Staff Report to the Agricultural Policy Advisory Commission

Application Number: **05-0629**

Project Description: Proposal to demolish an existing gas station and construct a replacement gas station and convenience store with beer and wine sales, install five gas pumps, construct a ~~car~~ wash, and re-configure the parking lot.

⑦ = landscape view
SITE PLAN
NSAHS 1/8" = 1'-0"

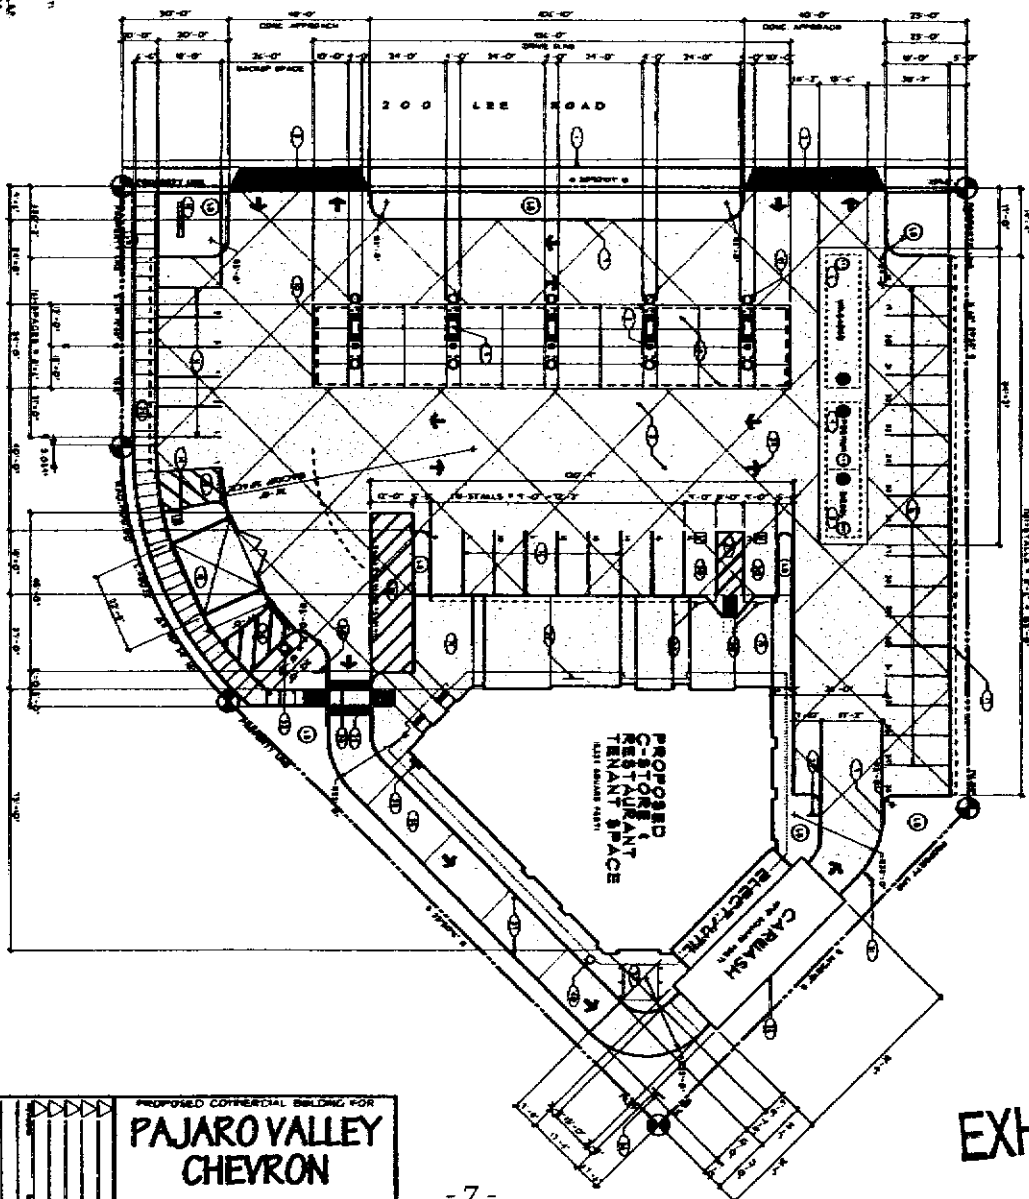
As can be seen from the table, the proposed canopy remains at about the same distance from the Willoughby property, but it is 30-feet closer to the Redmond property. The site plan also indicates that the width of the canopy facing the Willoughby property will increase from 24-feet to 136-feet. The proposed building exceeds the 200-foot buffer requirement from the Willoughby property but it reduces the existing setback from the Redmond property to less than 8-feet. The portion of the building closest to the Redmond property is the proposed car wash structure. There is virtually no change to the extent of the paved area on the property.

Finding 3: The gas station structure is proposed to be set back about **8** feet from the adjacent Commercial Agriculture zoned lands (the 15.6-acre Redmond Foundation organic farm). Also, the use within the rear area of the building consists of a car wash, resulting in **higher** public activity levels very close to CA land. No physical barriers **are** proposed to separate the uses other than ordinary chain link fencing and a narrow strip of low level landscaping. This is **an** inadequate physical barrier to supplant the required 200-foot buffer.

As proposed, the canopy will be slightly closer to the Willoughby property ~~than~~ the existing although the canopy will be over **5** times **as** wide facing that property. With the 75-foot width of the Lee Road right-of-way, the effective agricultural setback to the 84-acre Willoughby veggie farm would be 109-feet where 200 feet are required. This existing west setback is approximately 110-feet. Because this area is where the existing service station impacts occur and due to the expanse of the Lee Road right-of-way, the proposed improvements in this area are not a concern with regards to the agricultural buffer setback.

Finding 4: This finding cannot be made because alternatives have not been explored to provide the maximum buffering possible. These alternatives must include a review of site designs and barrier installations to provide the greatest possible setback distance ~~from~~ the agricultural land. As proposed, the service station is located as close to the Redmond organic farm property ~~as~~ possible (less than 8-feet ~~from~~ the agricultural land) with no adequate physical barriers.
